# Zenith Radio Corp.

Model: 4G800

Riders Volume 20 - CHANGES 20-17

**Zenith 4G800 Chassis 4E41**

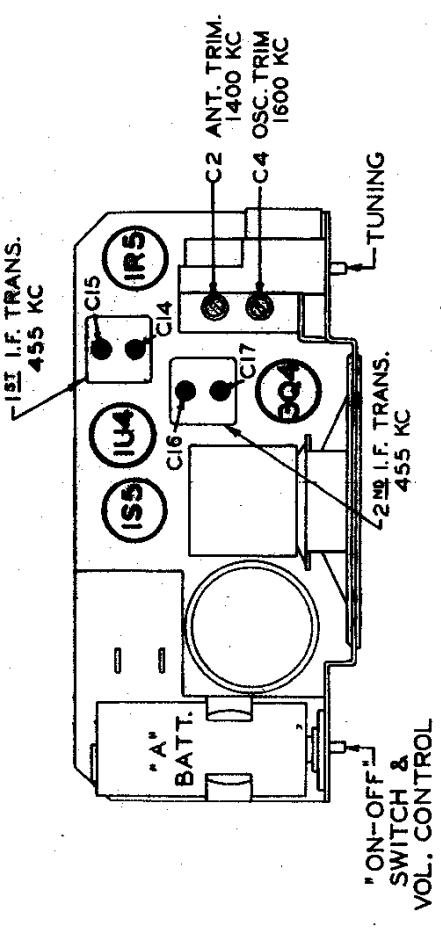
*Enough extra lead length should be left when replacing the wavemagnet lead on the Zenith 4G800 so that a break does not occur at the point indicated.*

In some cases when the front lid of the receiver is open, the receiver will cut in and out or sometimes be entirely dead. The wire from the wavemagnet to the front door hinge may break at the hinge connection. To correct this condition, remove the handle and resolder these leads, being quite certain that solder is not allowed to run back on the antenna lead and that enough extra antenna lead is allowed for flexing to prevent breakage when the door is open as illustrated in the accompanying diagram.
